**FINAL DRAINAGE REPORT FOR  
HOMESTEAD AT STERLING RANCH  
FILING NO. 1**

July 2018

Project #09-005  
DSD Project # SF-17-025

PROJECT NO. 09-005	SCALE: HORIZONTAL: 1"=80' VERTICAL: N/A	DATE: 4/12/2018
DESIGNED BY: CMN	CHECKED BY: VAS	SHEET 1 OF 1
		FDM01

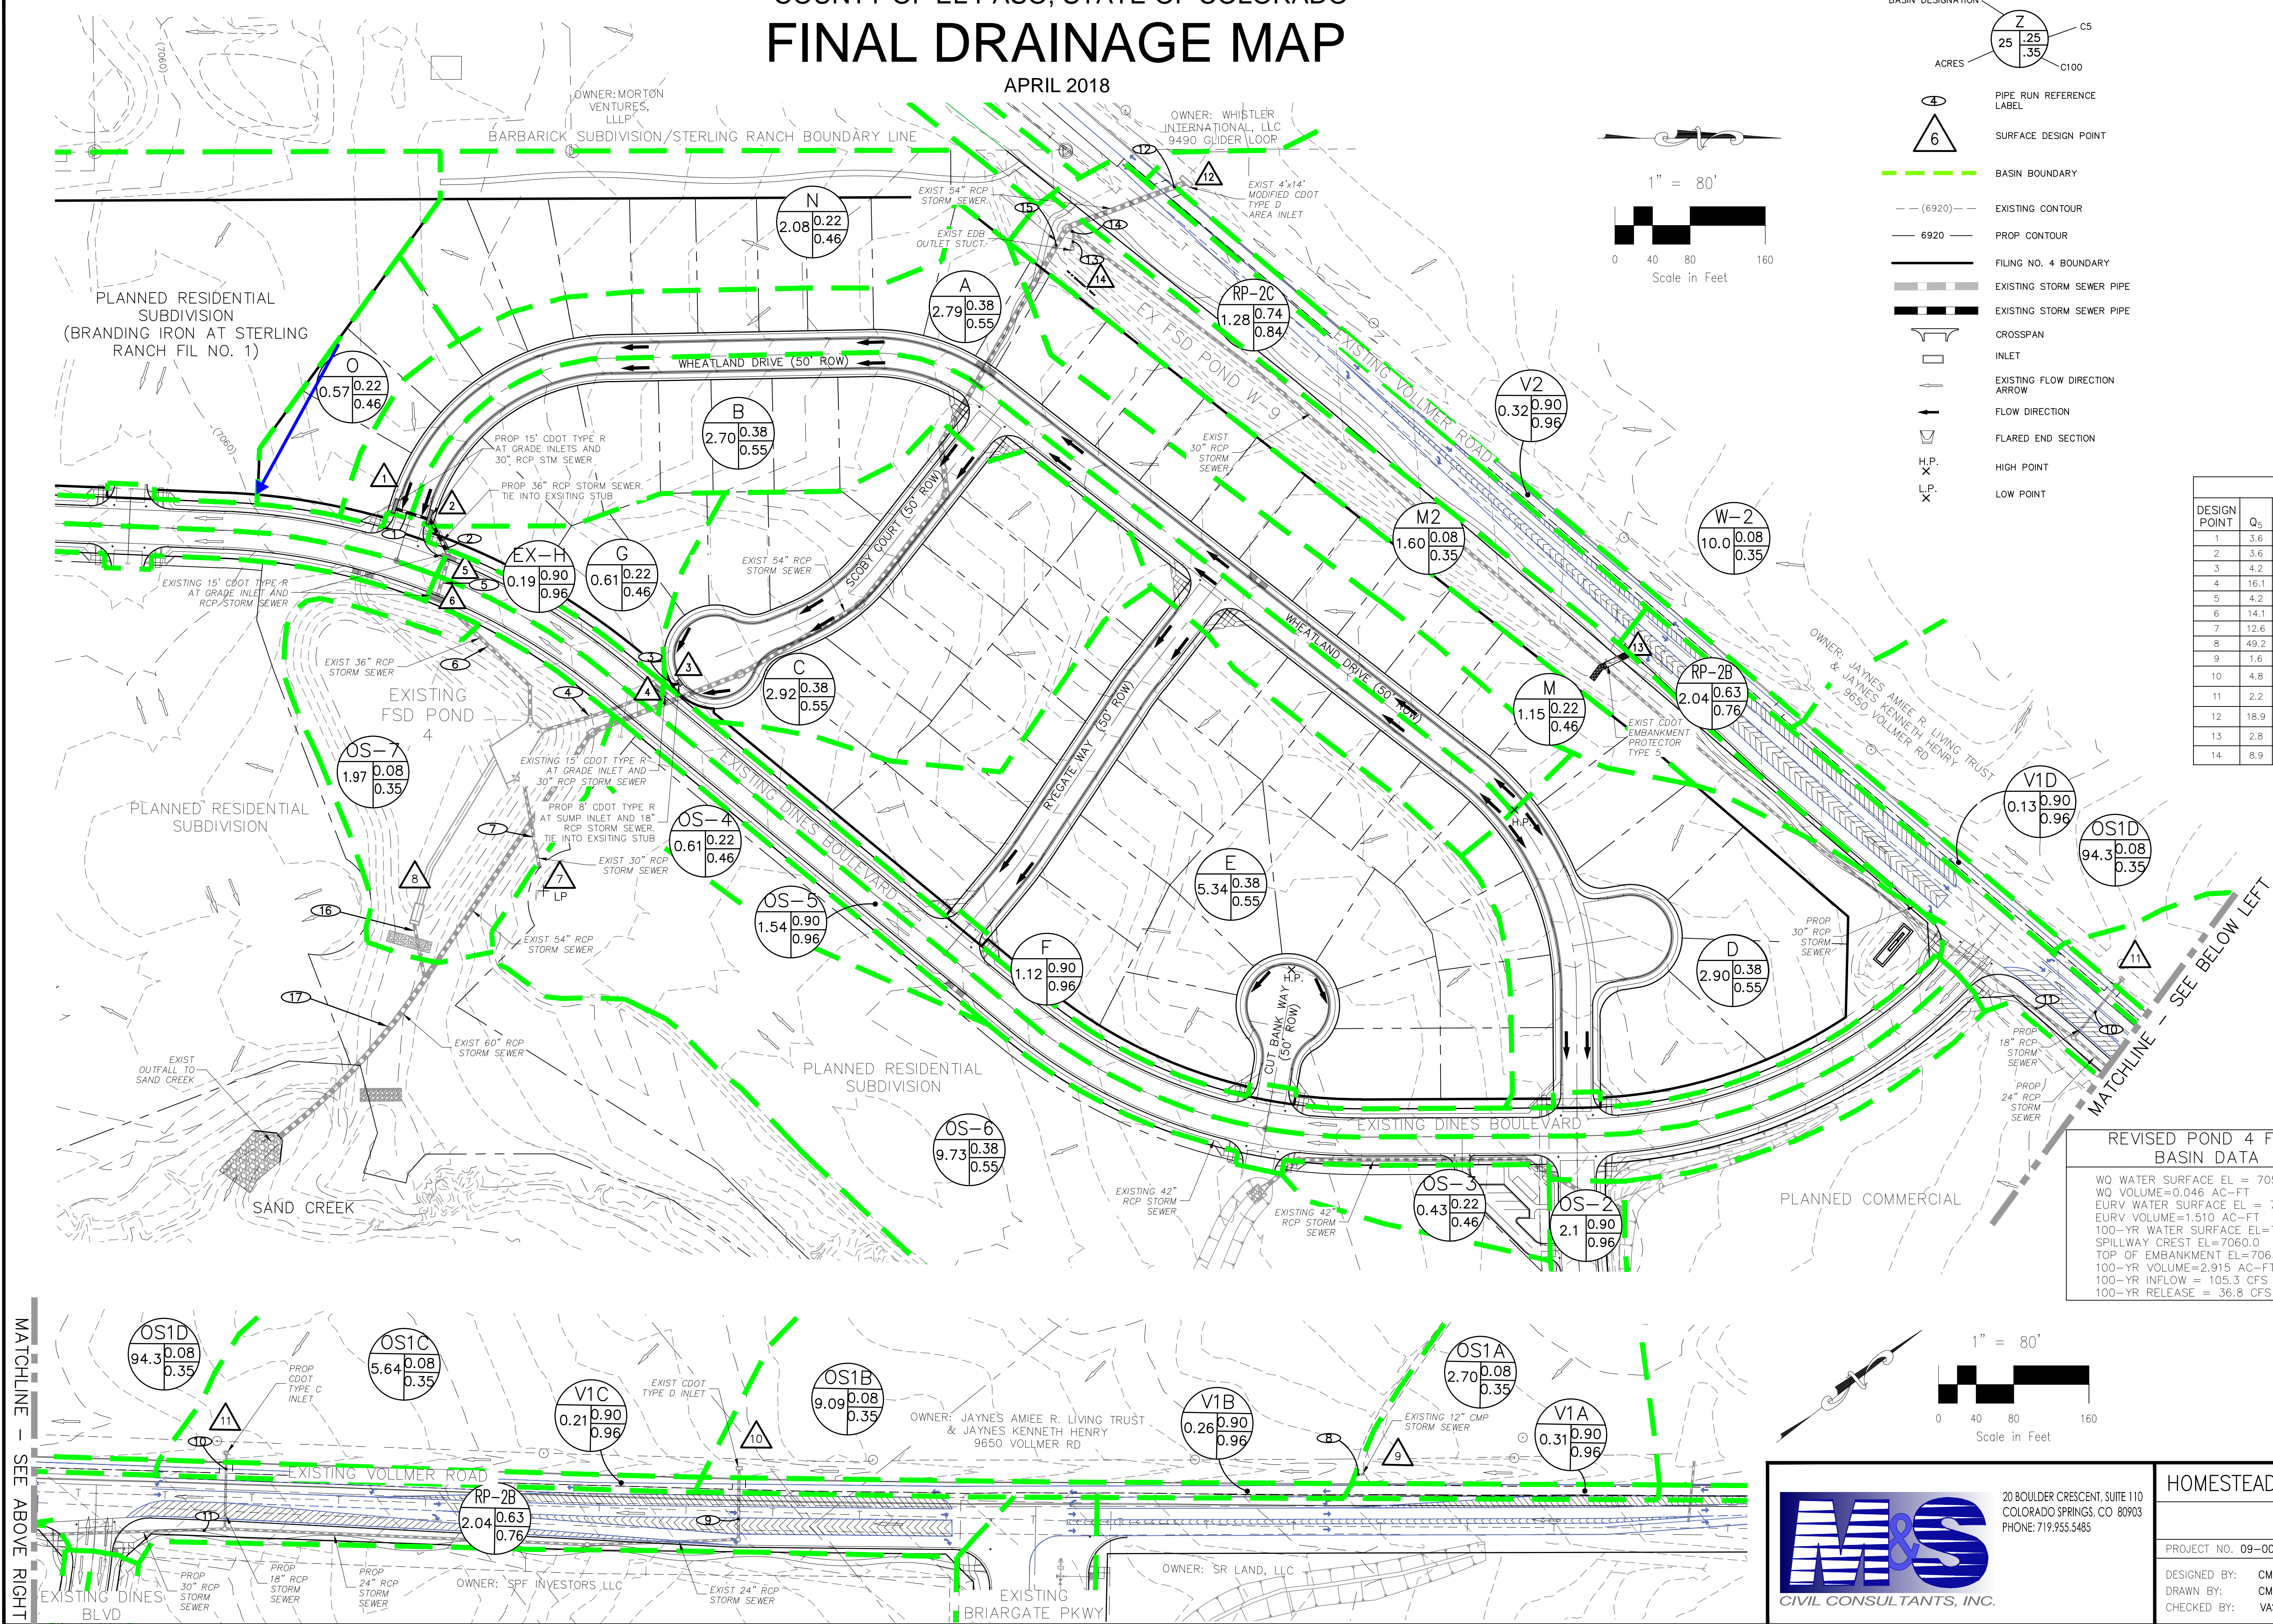
show rear lot swale
